# Access Compliance Report

## Public Rights-of-Way

### (Curb Ramps)

Intersection ID: 20697	Main Street: EMERALD_MEADOW_LN	Cross Street: SILVER_COACH_LN	Location: W
ADA ID: 75874333AD33	Ramp Type: PerpDiag	Initial Pass/Fail: Fail	Overall Compliance: No
		Severity Score: 12.5

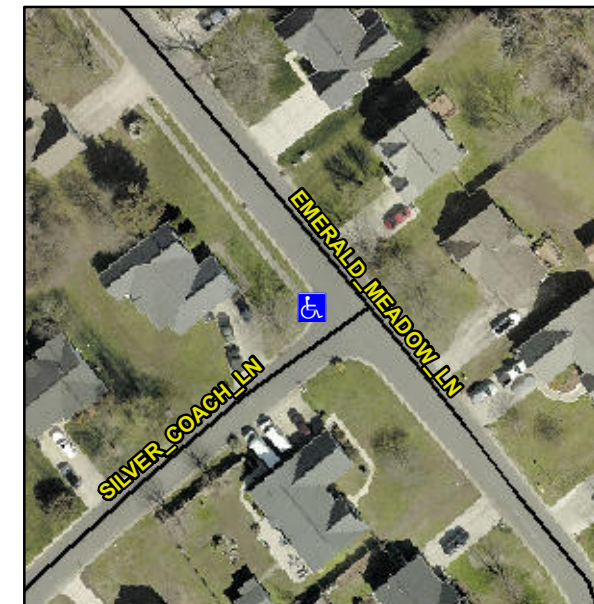
**R304.2.2**

Compliance	Description	Data	Compliance	Description	Data
N/A	Ramp Length (in)	48.0	No	Ramp Slope (%)	8.7
Yes	Ramp Width (in)	48.0	Yes	Ramp XSlope (%)	1.5
N/A	Flare Type LT	N/A	N/A	Flare Type RT	N/A
N/A	Flare Slope LT (%)	N/A	N/A	Flare Slope RT (%)	N/A
N/A	Flare Traversable LT?	N/A	N/A	Flare Traversable RT?	N/A
N/A	Landing Length (in)	N/A	N/A	DWS Provided?	N/A
N/A	Landing Width (in)	N/A	N/A	DWS Contrast?	N/A
N/A	Landing Slope (%)	N/A	N/A	DWS Length (in)	N/A
N/A	Landing X Slope (%)	N/A	N/A	DWS Full Width?	N/A
N/A	Landing Curb? (Y/N)	N/A	N/A	DWS Offset (in)	N/A
N/A	Shared Landing?	N/A			
N/A	Gutter Ponding?	N/A	N/A	Gutter Slope (%)	N/A
N/A	Gutter Lip Ht (in)	N/A	N/A	Gutter X Slope (%)	N/A
N/A	Painted X Walk1?	No	N/A	Painted X Walk2?	No
	X Walk 1 Direction	To SE		X Walk 2 Direction	To NE
N/A	X Walk 1 Width (in)	N/A	N/A	X Walk 2 Width (in)	N/A
	X Walk 1 Slope (%)	0.8		X Walk 2 Slope (%)	0.2
	X Walk 1 X Slope (%)	0.4		X Walk 2 X Slope (%)	0.7

**Remove & Replace Curb Ramp With Two New Directional Ramps or Equivalent.**
